## SITE PLAN REVIEW AND APPEARANCE BOARD STAFF REPORT

### 354 SE 5<sup>th</sup> Avenue - Waivers

Meeting	File No.	Application Type
November 9, 2022	2022-151-SPF-SPR-CLV	Class IV Site Plan
Property Owner		Agent
Delport Limited Partnership		Jeffrey Silberstein

Provide a recommendation to the City Commission regarding three waivers to the requirements of the Central Business District in association with a Class V Site Plan application to construct an 8-unit townhouse development.

Figure 4.4.13-G-3 Civic Open Spaces

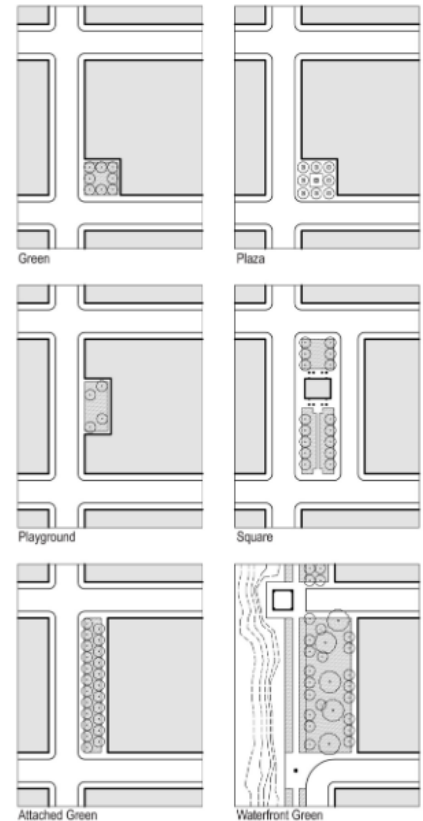
The Civic Open Space is meant to improve the pedestrian experience and “serve as an amenity for the city as a whole, as well as for occupants of the building which the civic open space serves.” As a result, the LDR is clear in directing that minimum required setback areas and minimum required streetscape standards shall not be credited towards civic open space requirements. These requirements are separate and distinct, and the provision of the tree lined streetscape is included within the scope of the project because the applicant is also required to do so pursuant to a different CBD LDR requirement. The provision of the street trees, a requirement applicable to all development within the CBD, shall not be seen as a tradeoff for diminishing the amount of, or eliminating, the civic open space.

Civic open space allows for larger structures to integrate into the built environment in a way that does not detract from the public realm. In addition, one of the foundational purposes of requiring that civic open space be integrated into developments with larger total lot area is so that natural breaks and articulations are integrated into the building massing to mitigate potential negative impacts from large scale structures with considerable bulk. As a result of these important design details, the pedestrian experience is greatly enhanced by the softening of harsh facades that may otherwise appear to dominate the public space.

Regarding the waiver criteria, the Board should consider if the proposed omission of civic open space is directly at conflict with many of the findings. By way of eliminating the provision of civic open space, both the provision of public facilities (i.e. a public space) is diminished and the quality of civic open space is reduced. SE 5<sup>th</sup> Avenue is a primary street, and the diminishing of public facilities and reduction in the quality of civic open space along the street frontage will result in an inferior pedestrian experience along the street as compared to what would otherwise exist if the required civic space was provided. In addition, part of the Board's consideration is if the request to eliminate the required civic open space is a special privilege. There are no identified hinderances by the configuration of the land, only the proposed development design, that have necessitated the elimination of a civic open space. Therefore, the omission of civic open space should be considered a special privilege. Further, no waivers to allow the elimination of a required civic open space have been considered for any project within the CBD district since the adoption of the subject regulation in 2015.

#### **Waiver #2, Façade Composition Proportion Requirements**

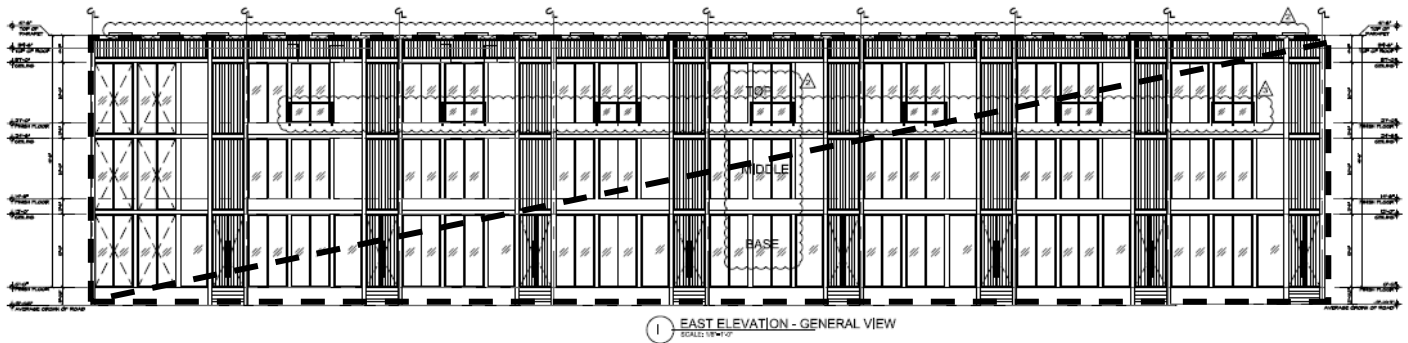
The applicant has requested the ability to propose an architectural design composition that provides a facade proportion that exceeds the established maximum width to height ratio of 3:1 or 1:3, instead proposing a proportion ratio of 5:1. The compositional requirements are established so as to ensure high quality architecture in the downtown area. The composition ratios help facilitate development on properties comprised of multiple consolidated parcels of significant width in a way that is reminiscent of and consistent with the historical development pattern of Delray Beach, which largely occurred on lot sizes of width ranging from 25 feet to 150 feet. By introducing maximum proportion ratios, developments of larger lots that take up significant percentages of a city block, even with homogenous design, can be articulated in a way so as to reflect the scale of the historical and desired development pattern.

Allowing compositions absent of any differentiating articulation or design detail that breaks up the homogeneity of the massing, wherein the width of the façade exceeds the maximum ratios established as contextually appropriate, imparts a negative effect on the public realm wherein the heaviness and

repetition of structure appears out of scale and incompatible with established design and development patterns. The proposed design composition provides a homogenous repetitive façade that extends 204 linear feet, with a height of 41.5 feet, thereby equating to a ratio of five feet of width for every one foot of height.

The Board must consider if the request is inconsistent with the applicable findings given that the approval of the waiver would result in a primary façade that is out of scale with the historical and desired development pattern; emphasizes the heaviness of the massing and the structure's imposing relationship with the pedestrian realm, which are both deemed to be detrimental to the quality of the pedestrian experience along a primary street; and further constitutes a special privilege being that there is nothing unique to the property that precludes the applicant from adhering to the compositional requirements, which have been determined through the adoption of the CBD regulations to be appropriate and most successful in achieving a compatible scale of development.

### Waiver #3, Removal of Deck Around Rooftop Pool

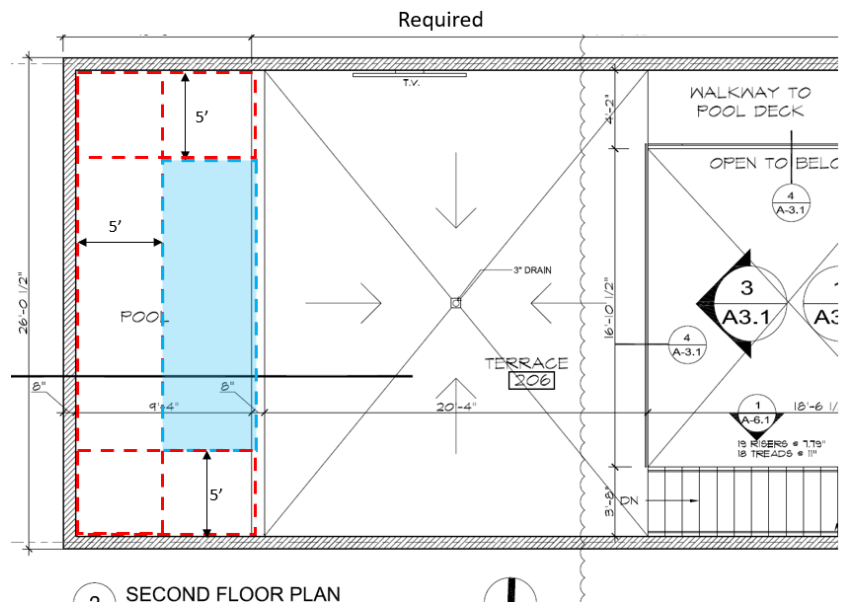
The applicant is proposing a pool configuration on the second floor of each unit that provides no setback on the sides and the rear of each pool, instead of the minimum 5-foot deck that is required around the perimeter of a rooftop pool. The only separation between each pool is a shared CMU wall. Should the waiver be approved, the pool design will still be obligated to comply with all applicable Florida Building Code requirements and any waiver approval would not supersede other applicable requirements. It is the responsibility of the Design Professional to ensure the proposed design complies with all applicable building codes at time of permitting.

It is important to note that the intent of the requirement to provide a five-foot wide (minimum) deck around the perimeter of a rooftop pool is generally based on safety precautions in that there is a clear and accessible means of ingress/egress from the pool area on all sides in the event an emergency were to occur. As proposed, the lack of egress on three of the four sides of the pool creates potential safety issues and is at conflict with the waiver criteria related to creating an unsafe situation. While handrails mounted to the side walls may be a potential strategy to mitigate the fact that there is no point of egress on three sides, the Board should consider whether providing a 5' deck on all sides of the pool creates an environment that is safer than the configuration proposed.
